MARKSHEFFEL ROAD - SEGMENT M3

EL PASO COUNTY, COLORADO STREET IMPROVEMENT PLANS

PCD FILE NO. CDR-2413

SIGNAGE AND STRIPING NOTES:

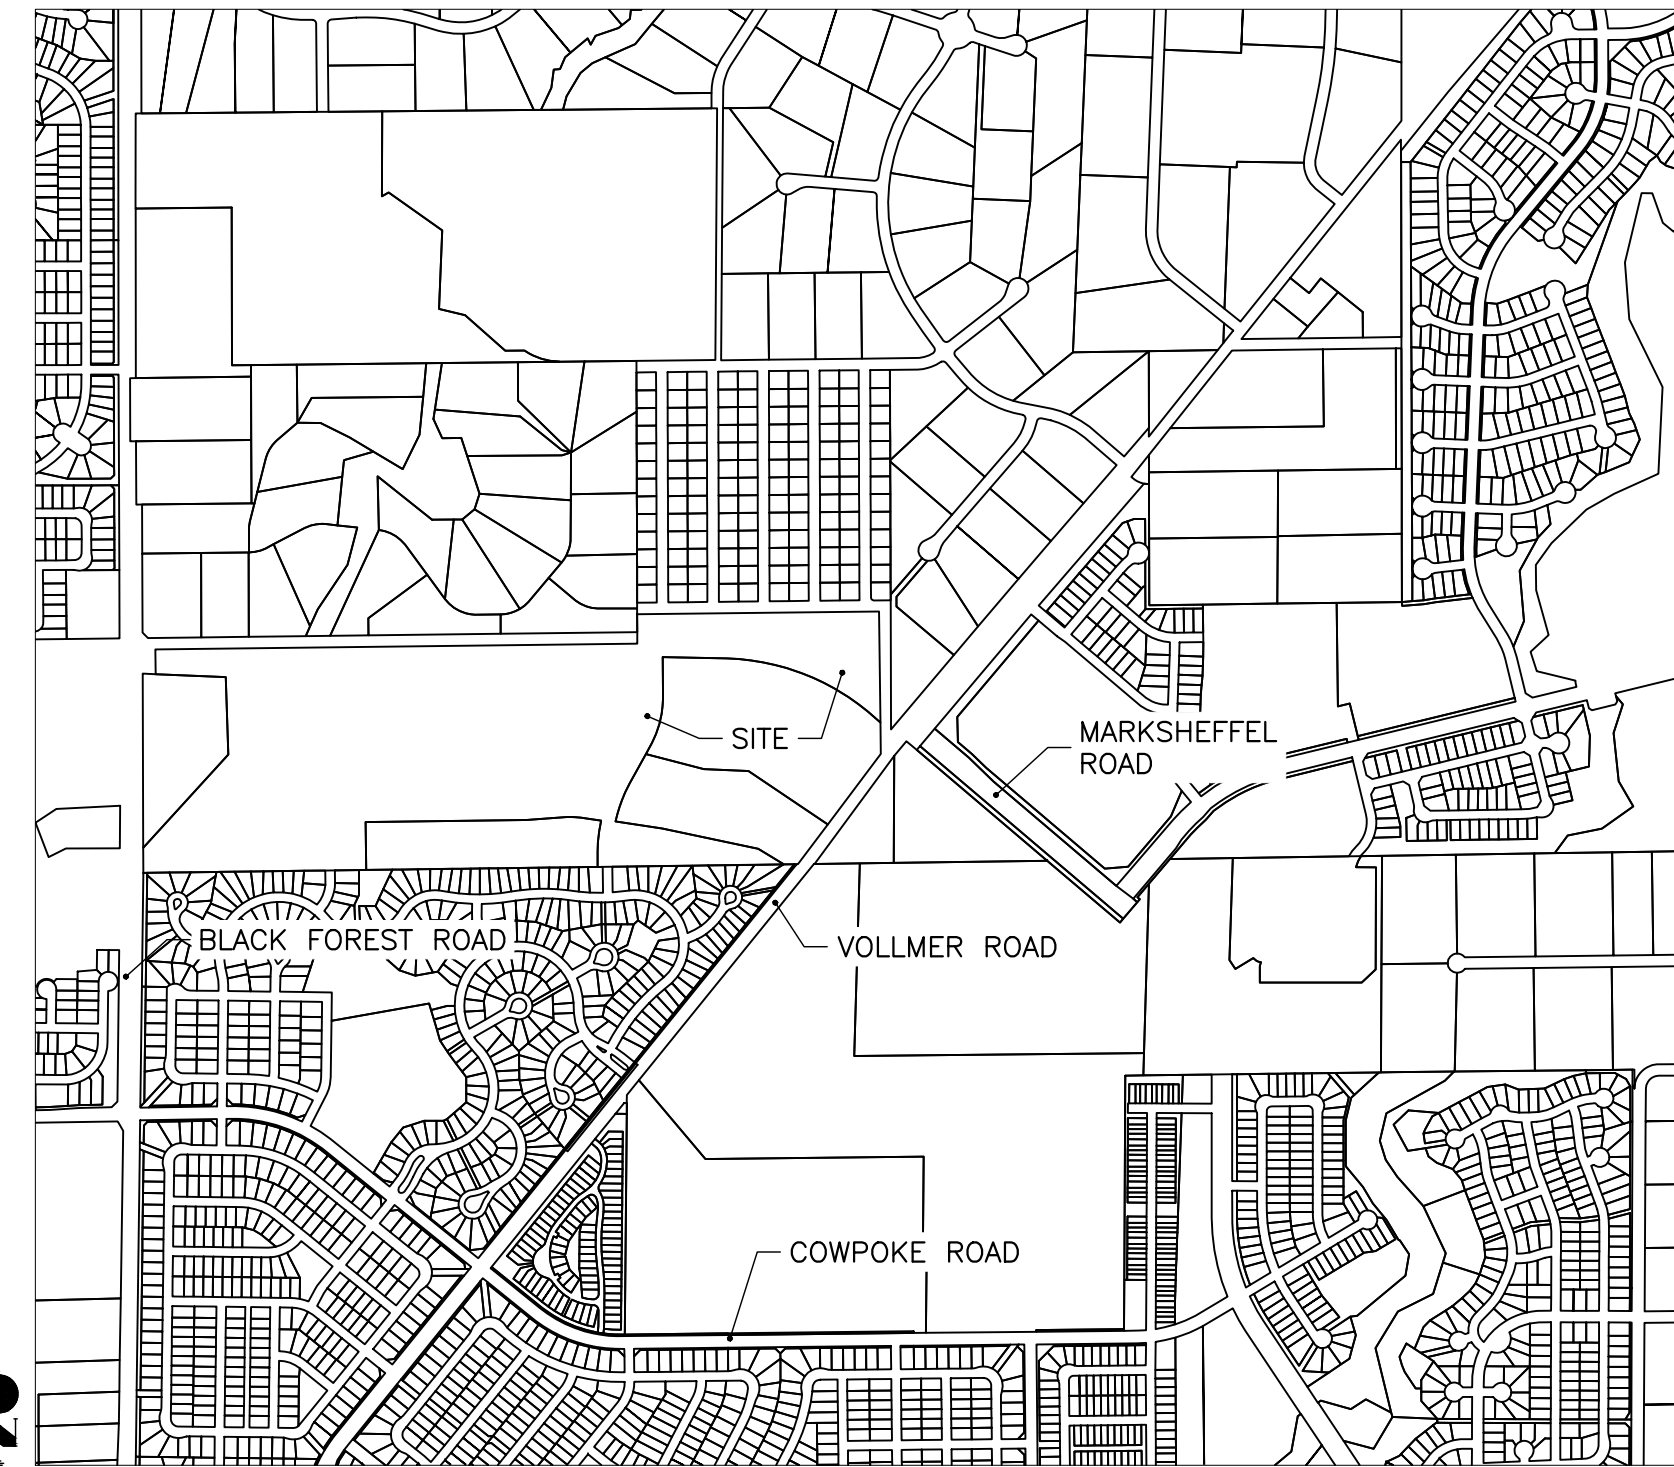
Please update to the 2026 signing and striping notes

MARKSHEFFEL ROAD - SEGMENT M3
CURB RAMP DETAILS

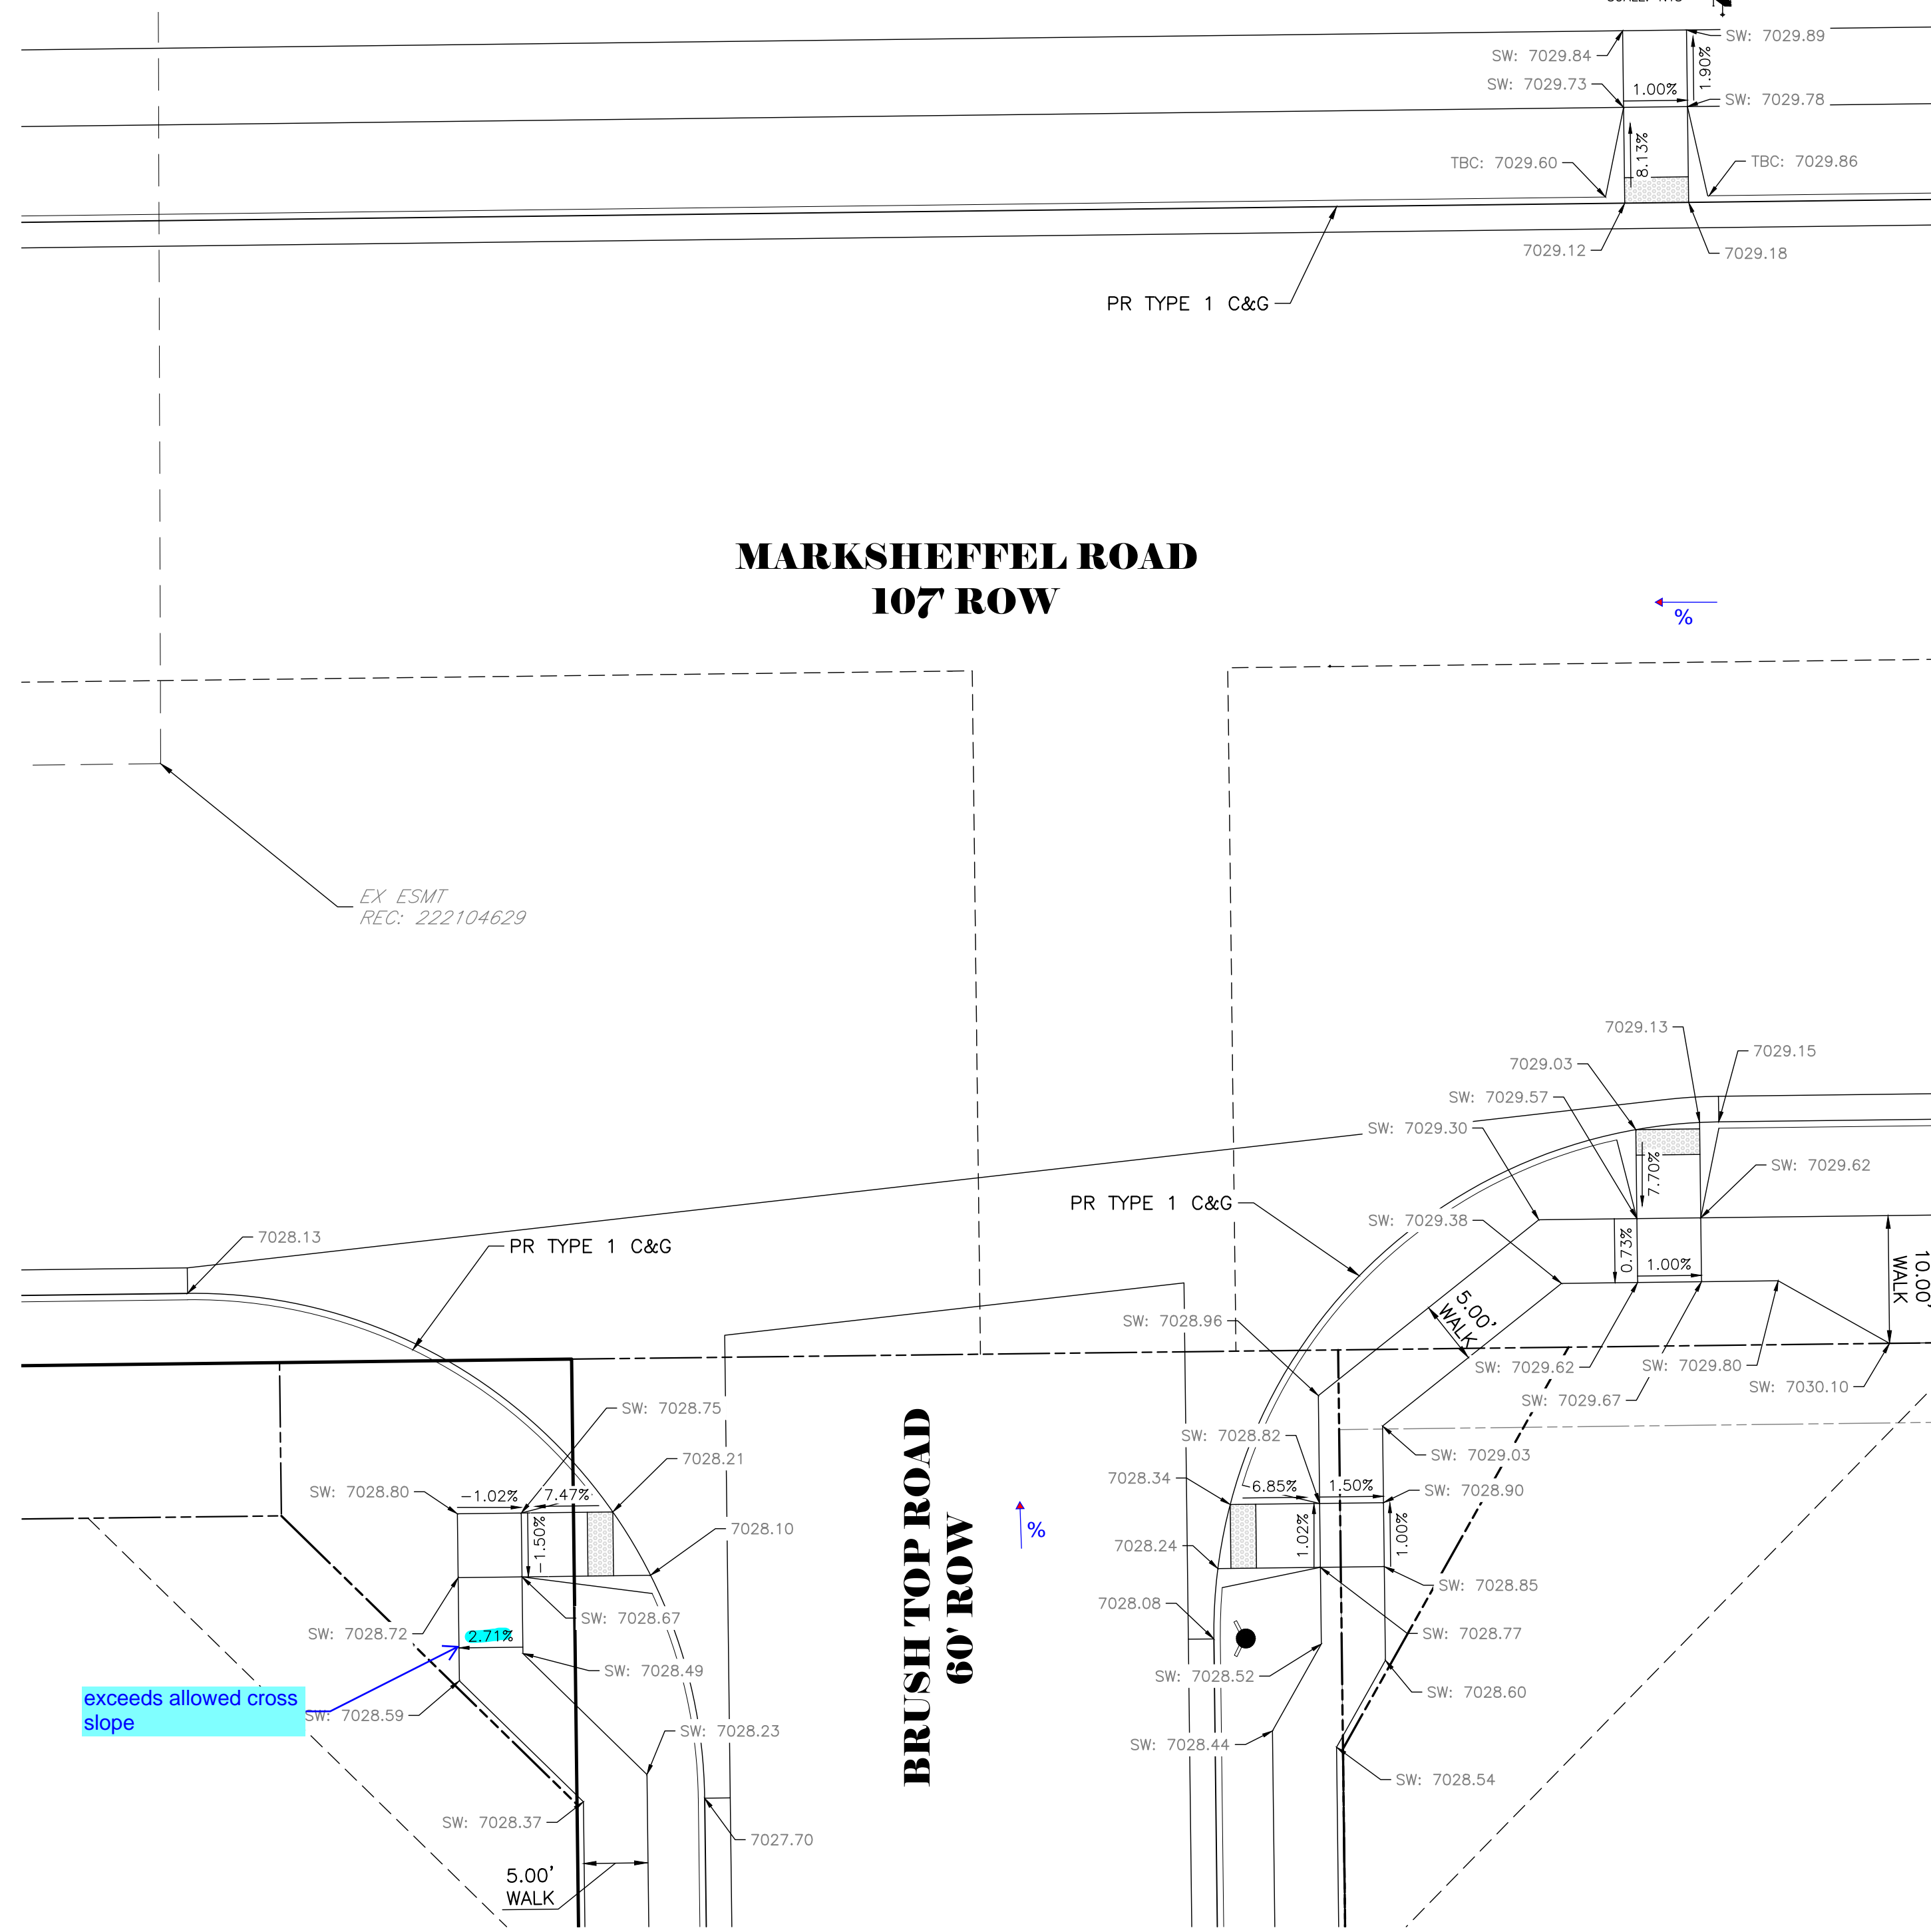
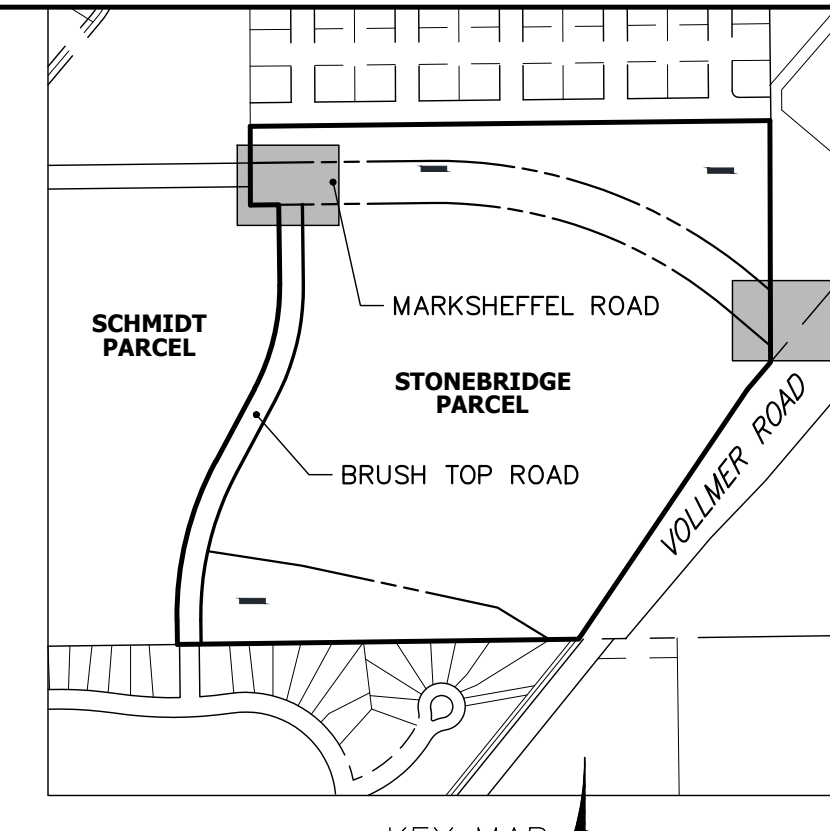
Please include cross walk grade for all intersections

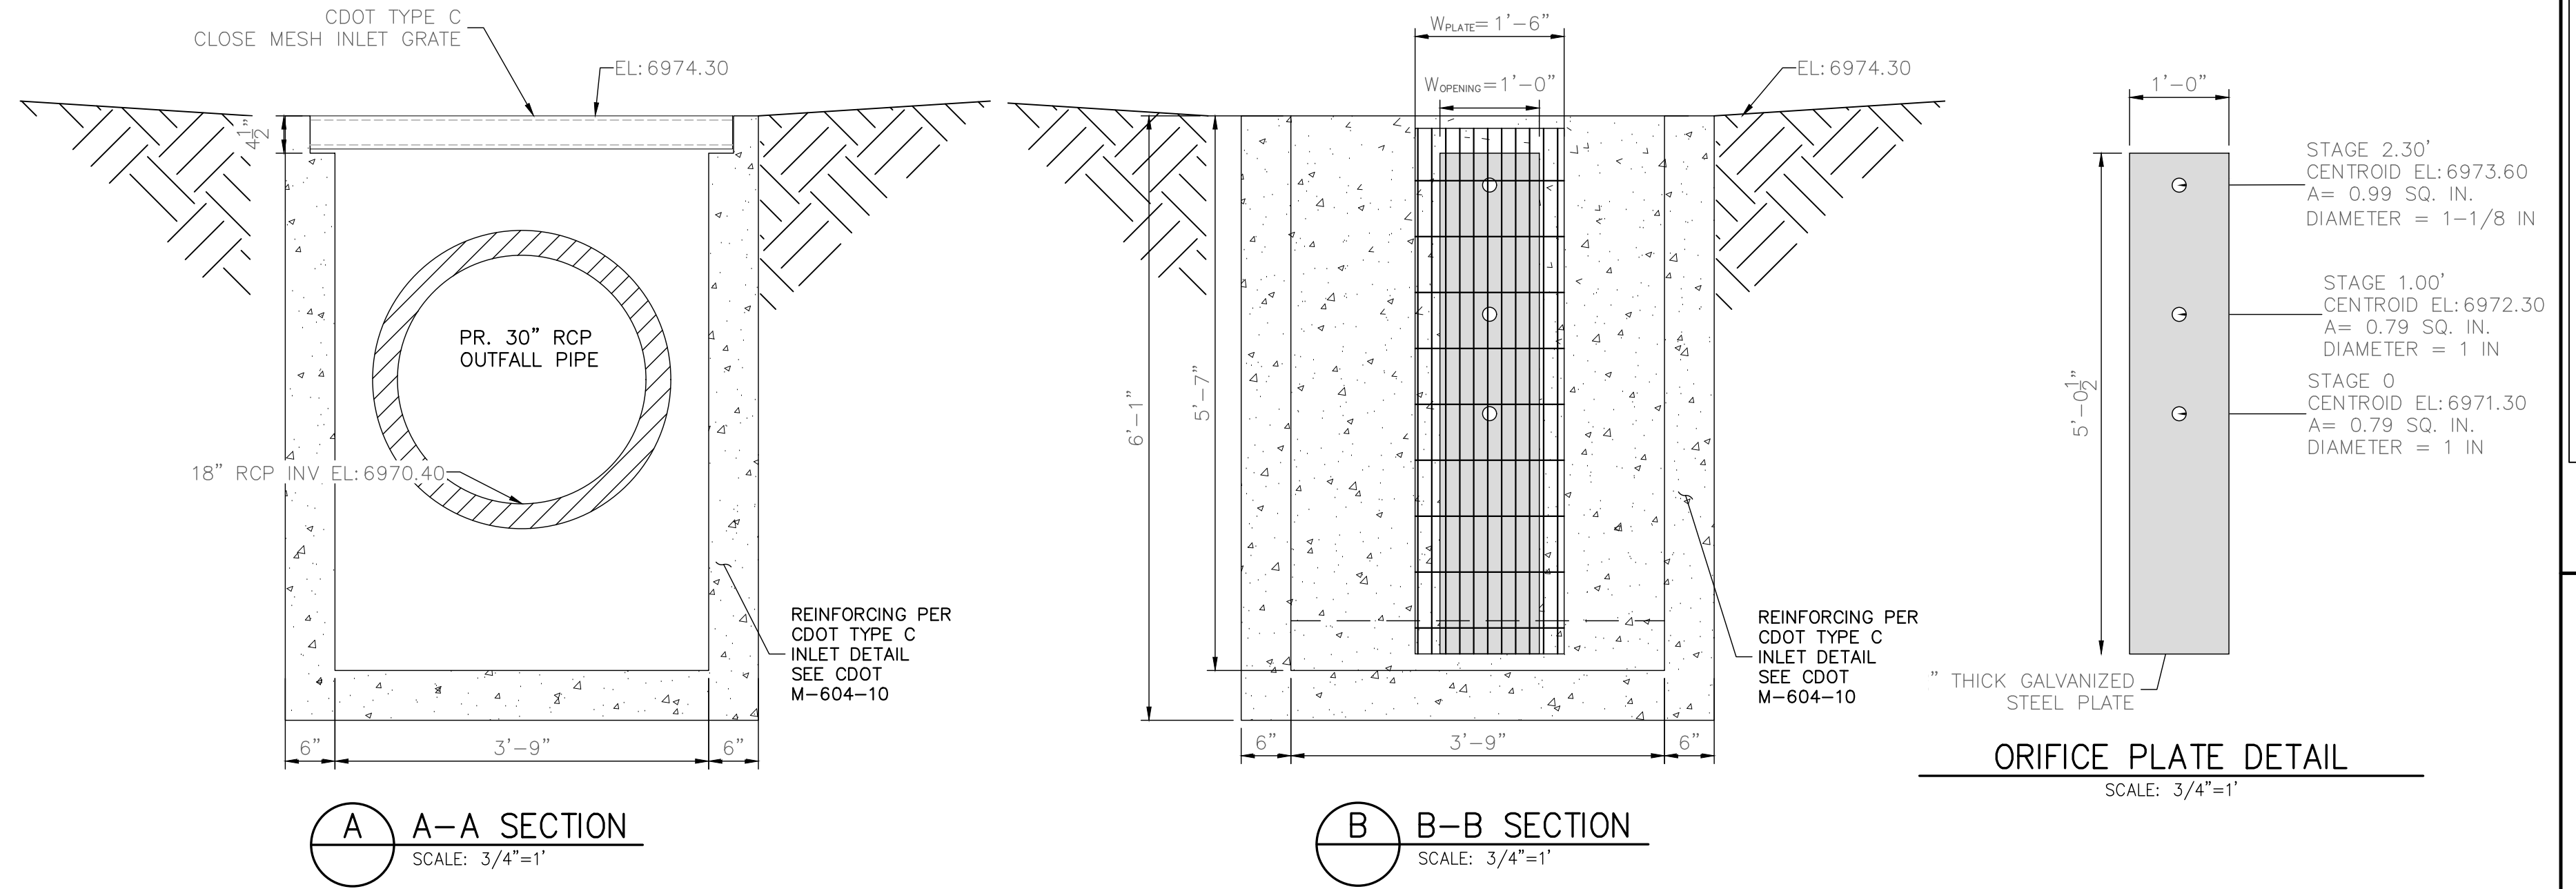
Provide detail on how the triangular trickle curb microchannel will tie-into the concrete square curb microchannel. This location labeled invert should be the top of the trickle channel so the trickle channel is flush with the pond bottom. With this detail it appears the trickle channel would be floating above the pond bottom and with similar details we have seen triangular trickle channels are built that way.
